12/16/2019 – Comments on the Proposed Woodmark Project

Subject: Proposed Woodmark project comments

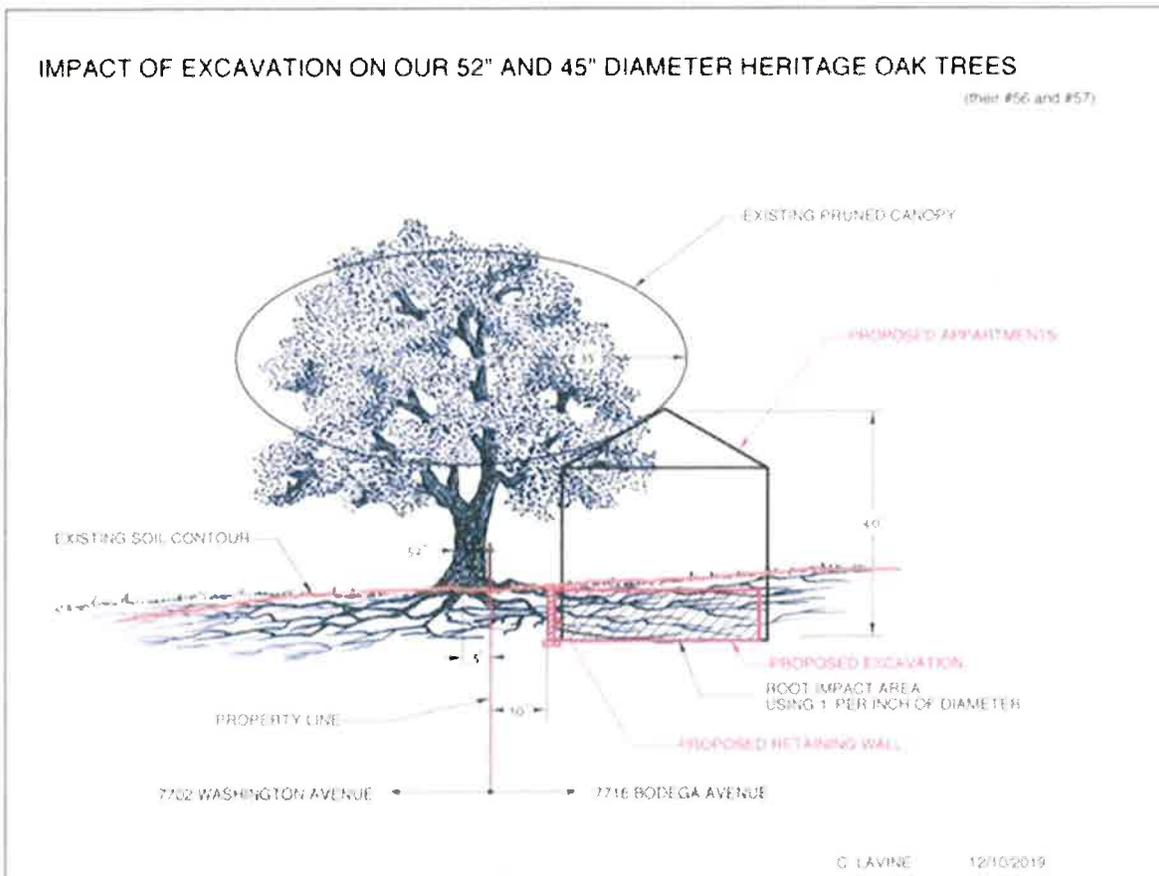
Pacific Properties has asked for a 10' rear set back variance and wants to excavate the rear property and build a retaining wall with a height ranging from 8' to 16'. The retaining wall will also require at least 4' – 6' wide footings which will effectively cut all of the tree roots 8' from the fence line. There is no question the trees will die.

I've included an elevation drawing which I think more clearly shows the reality of Pacific Properties proposed design and the hazards it presents to our and neighboring heritage trees where the proposed set backs are 5' and 10'.
